Addendum No. 03

Memorial Stadium Modernization

Fieldhouse & Stadium

MADERA UNIFIED BID NO.: 073025
PBK PROJECT NO.: 20-51
DSA APPLICATION NO.: 02-121624 Fieldhouse
02-122784 Stadium

A1.2

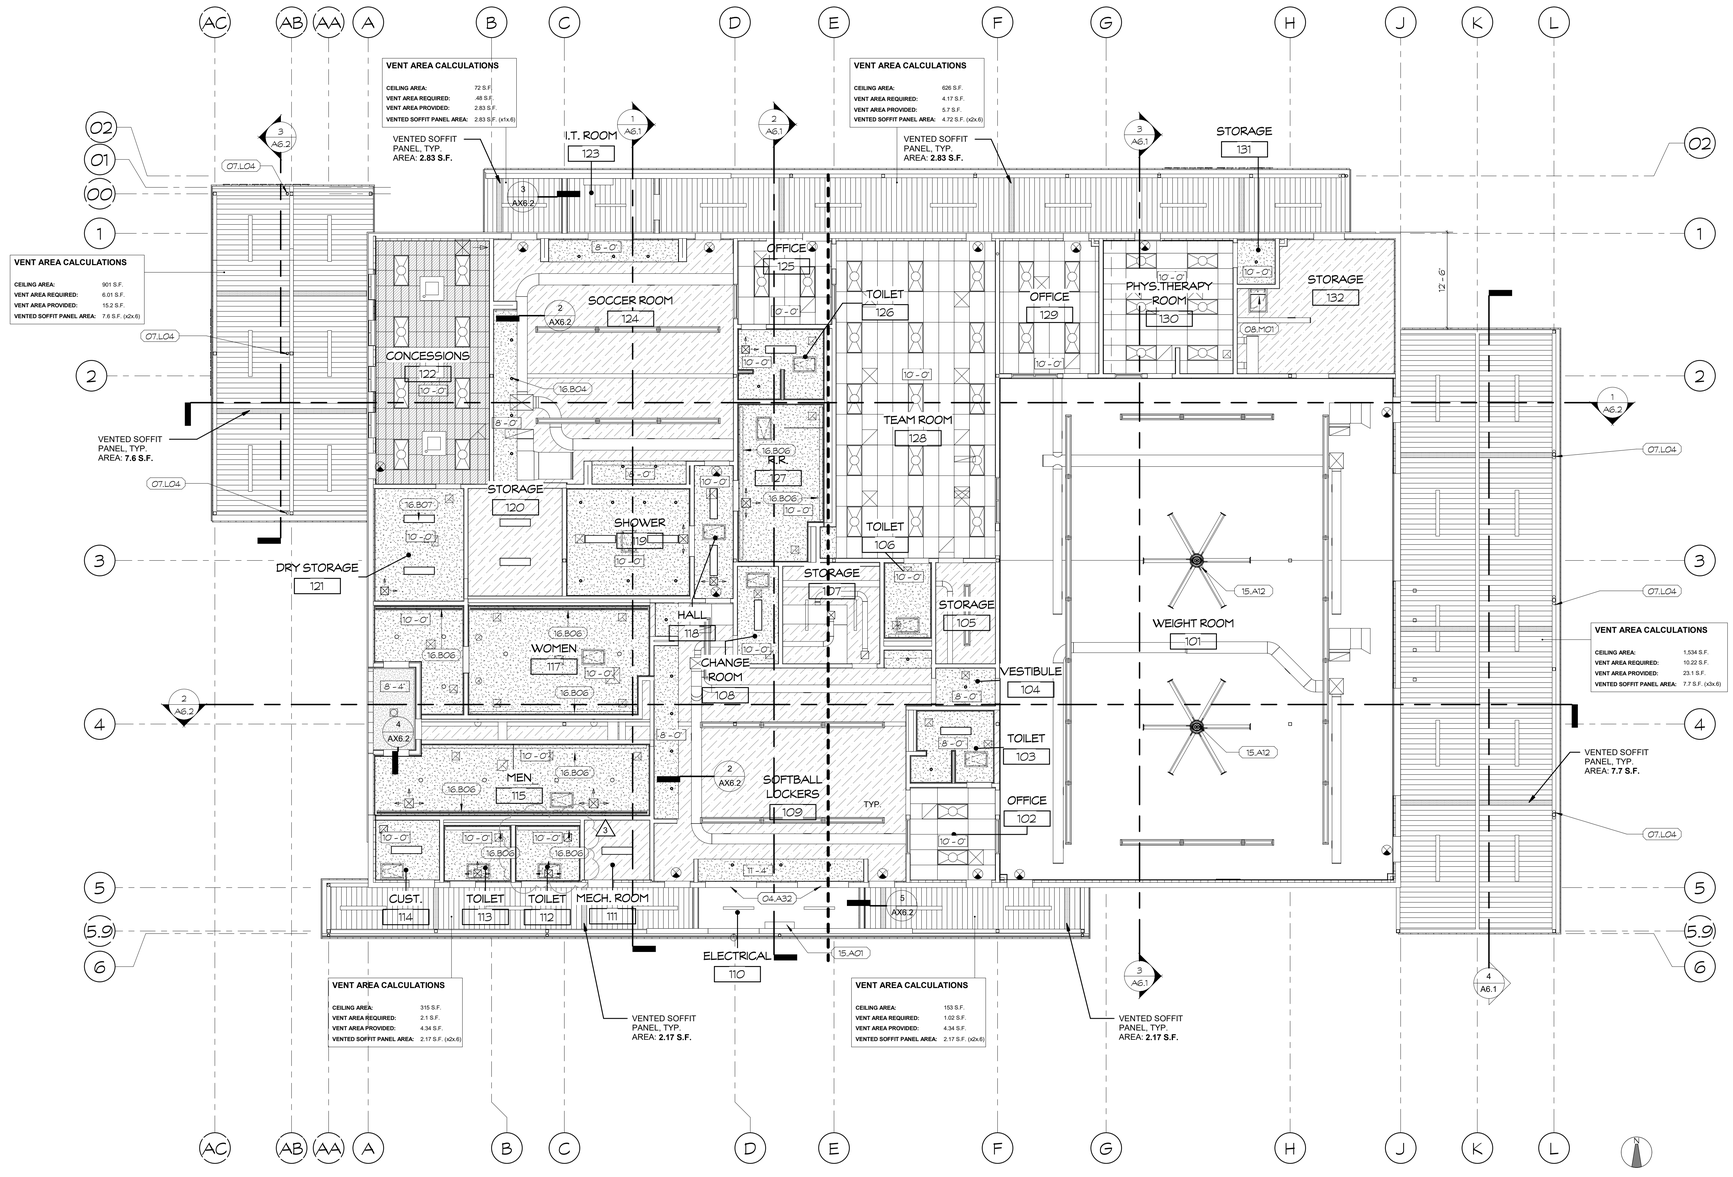
a. A1.2 – NOTED FLOOR PLAN
   - Relocated overhead coiling doors to exterior side of concessions.

A3.1

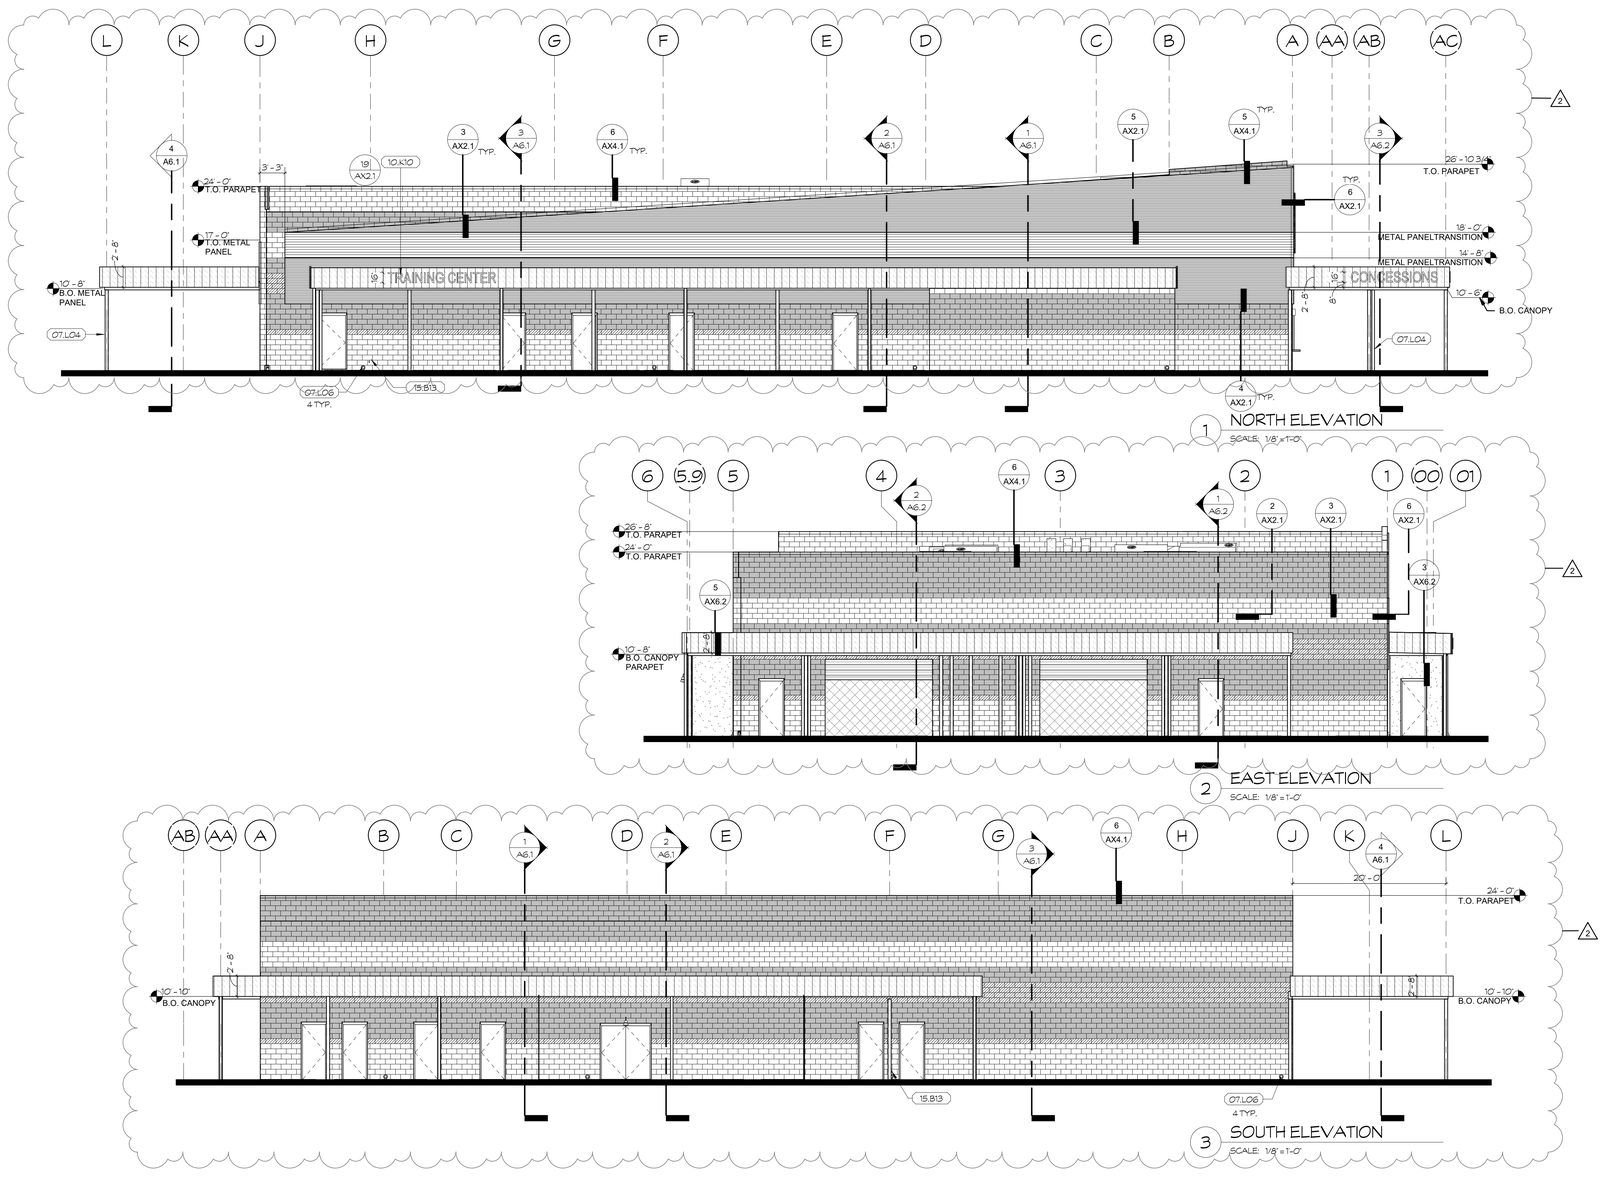
b. A3.1 – REFLECTED CEILING PLAN
   - Revised ceiling height.

A5.1

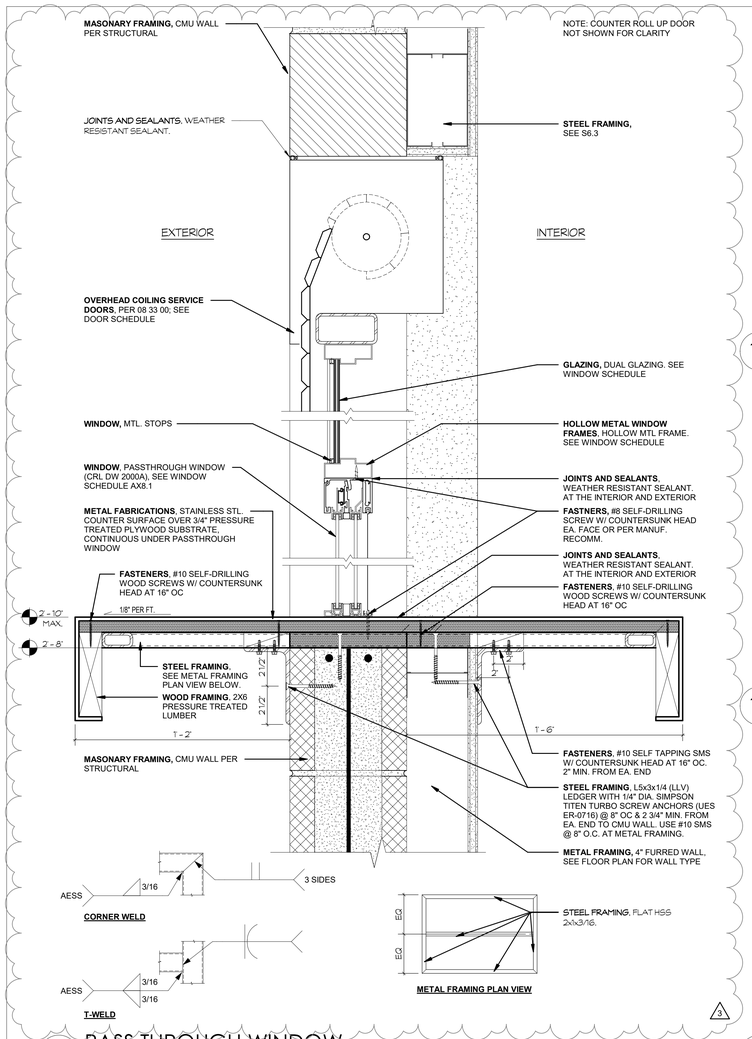
c. A5.1 – EXTERIOR ELEVATIONS
   - Relocated overhead coiling doors to exterior side of concessions.

AX3.1

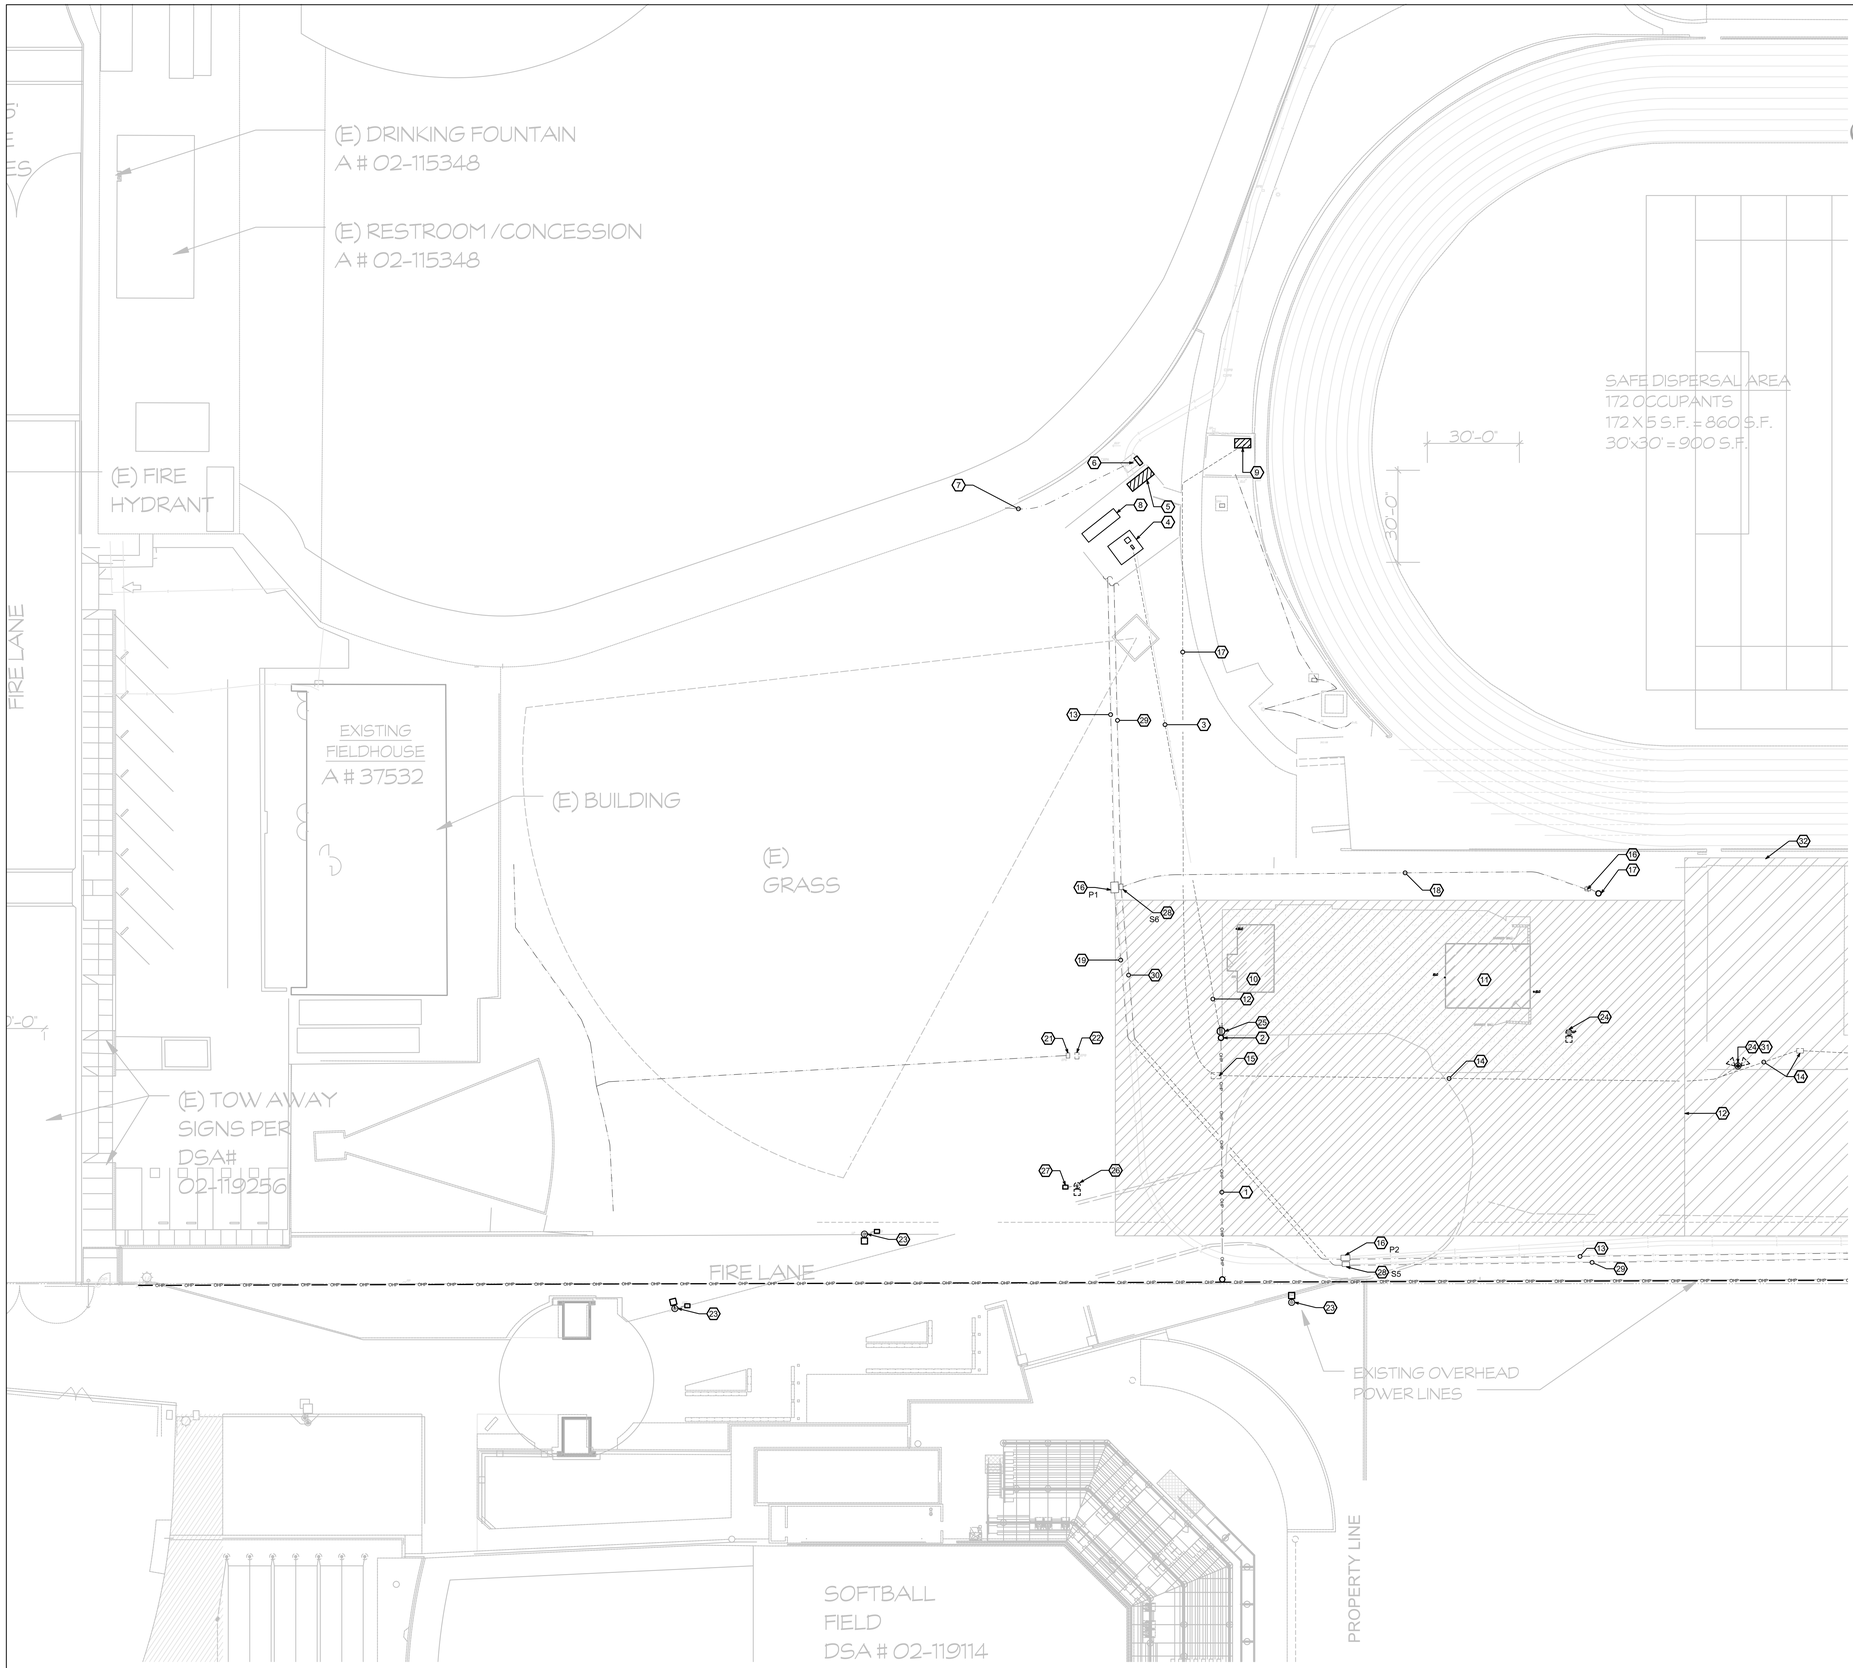
d. AX3.1 – OPENING DETAILS
   - Revised opening details.

ES1.1

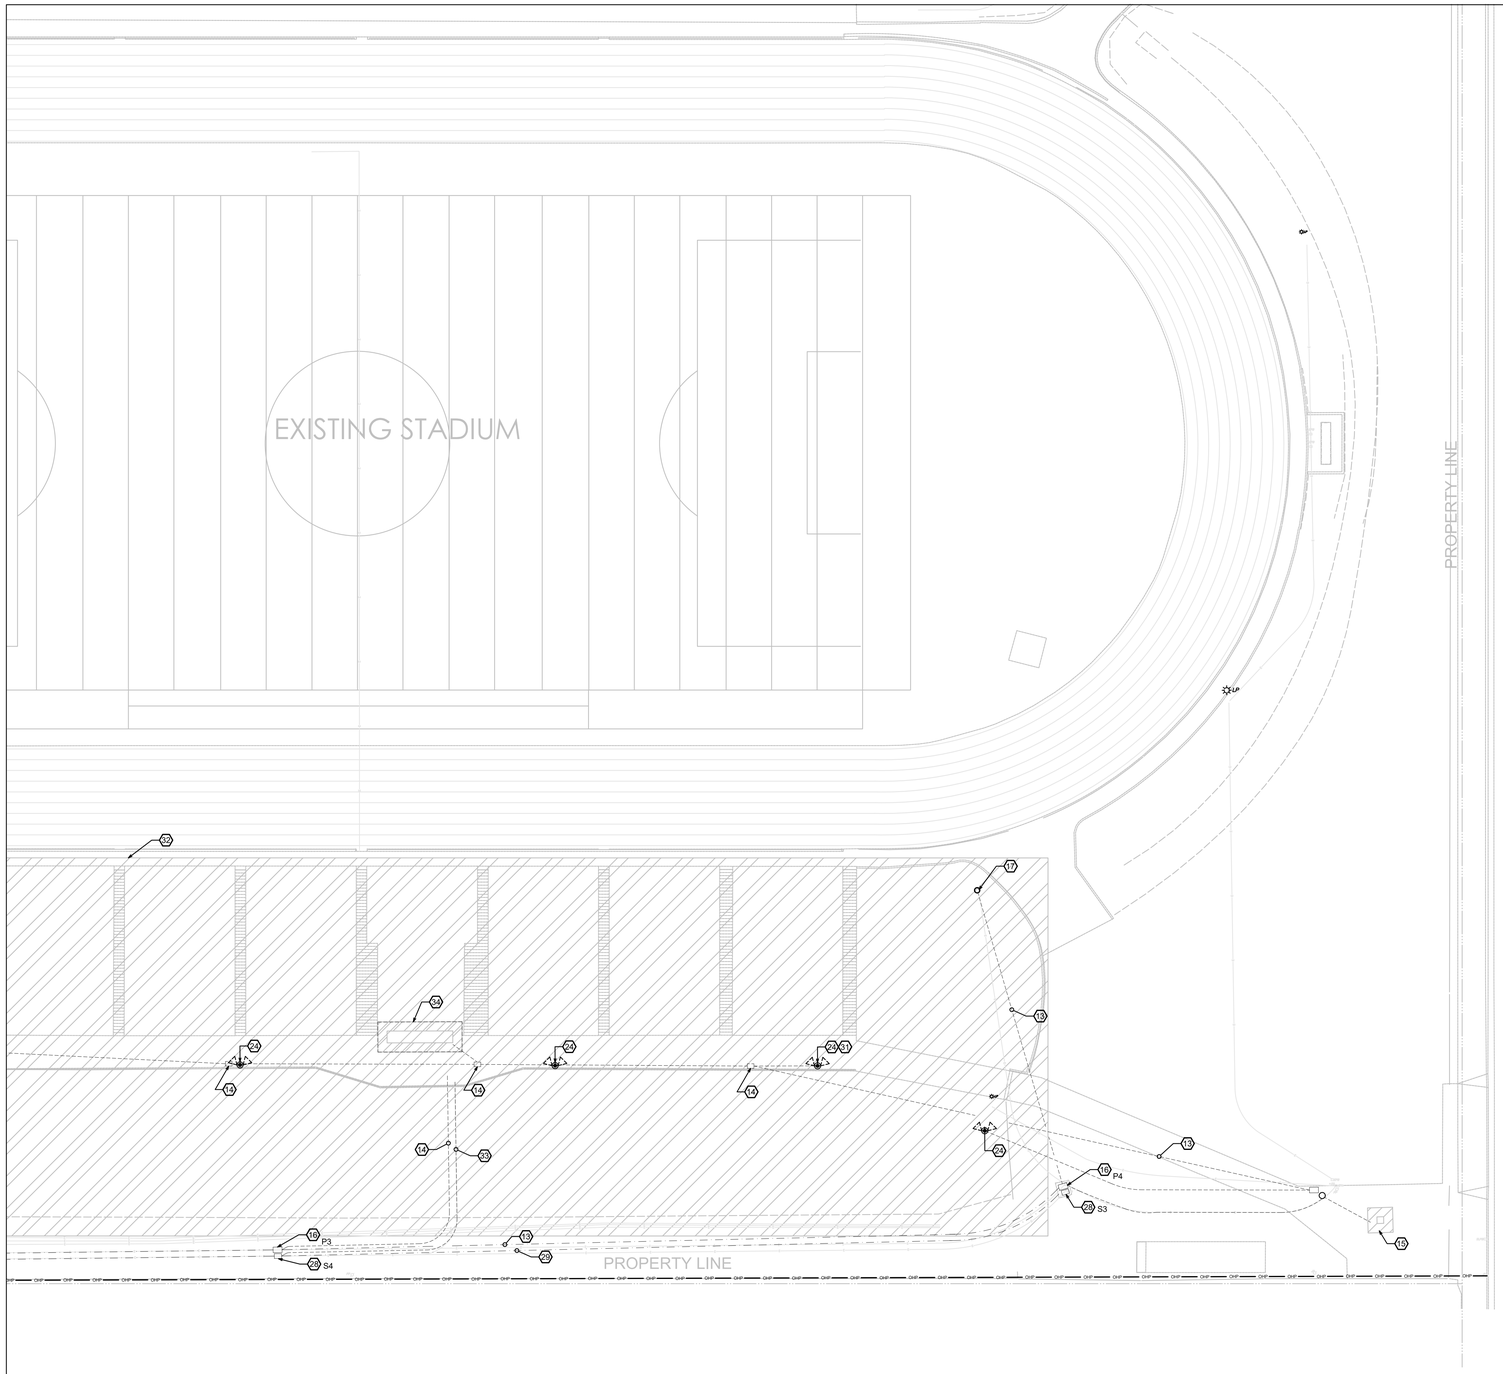
a. ES1.1 - ENLARGED DEMOLITION ELECTRICAL SITE PLAN
   - Modified Keynote 4.
